1 **SAMISH WAY URBAN VILLAGE**

2 **City Council Work Session**

3 November 9, 2009

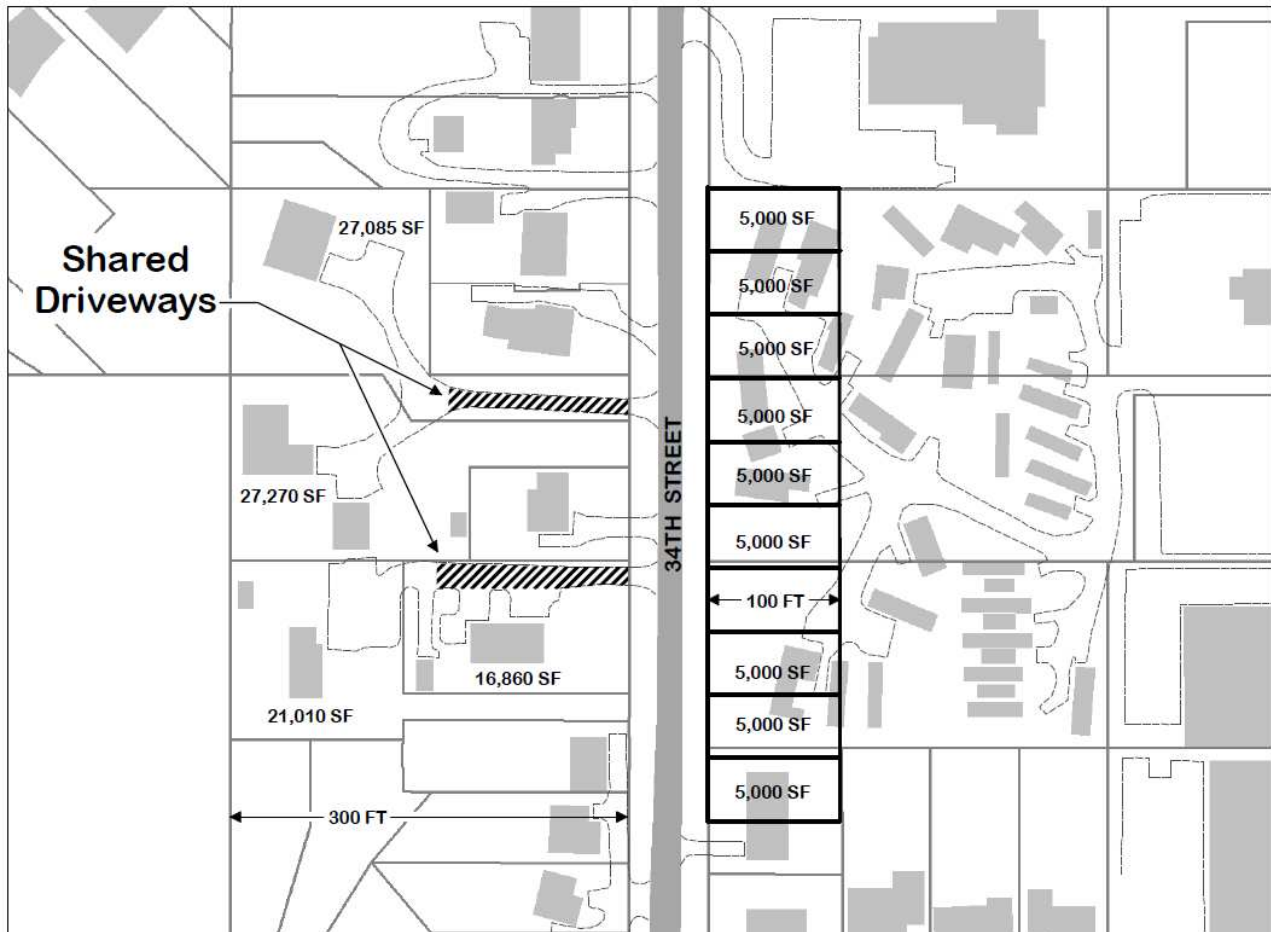
10 **2. Concern regarding vehicular access to residential streets (primarily 34th):**
11

16 Shared driveways are not a predominant characteristic of 34th Street as it exists today.
17 There are 22 existing residences on the west side of 34th Street; out of these, only 9
18 share driveways. This is primarily due to large lot subdivisions that required the
19 creation of “pipestem” lots to comply with street frontage requirements. (See figure
20 below).
21

12 Staff comment: See proposed change 2D in the previous section regarding the
13 restriction of commercial access. Staff recommends individual driveways be permitted
14 when an alley alternative is not available.
15

Figure .130-A. Massing and Articulation

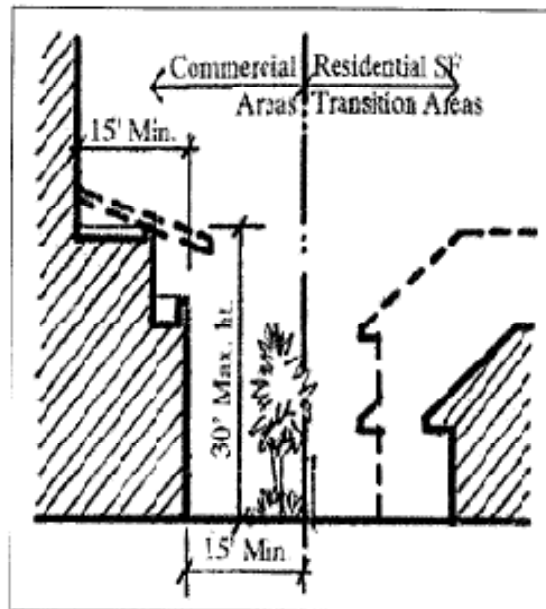
1 **3. Concern regarding transitions from Commercial to Residential zones in the**
2 **York Neighborhood.**

b. **Standard:** A building shall be set back a minimum of 15 feet from a property line abutting or across a right-of-way from a Residential Single Zone or a Residential Transition area. (See Figure .130-A)

b. **Standard:** The maximum height within 30' of a property line abutting or adjacent to a Residential Single Zone or a Residential Transition area shall be 2 stories and 30 feet. (See Figure .130-A)

3
4 Staff comment: The proposal sufficiently addresses the transition between commercial
5 and residential.

9
10
11 The proposed design regulations also require that commercial buildings be located
12 along the commercial street frontage, which results in the building mass being located
13 away from the residential areas. Reducing the height limit would discourage
14 redevelopment and development that does occur would likely be constructed with
15 surface parking.

18
19 Increase the setback or upper story step-back requirement when adjacent to a
20 residential zone.
21
22
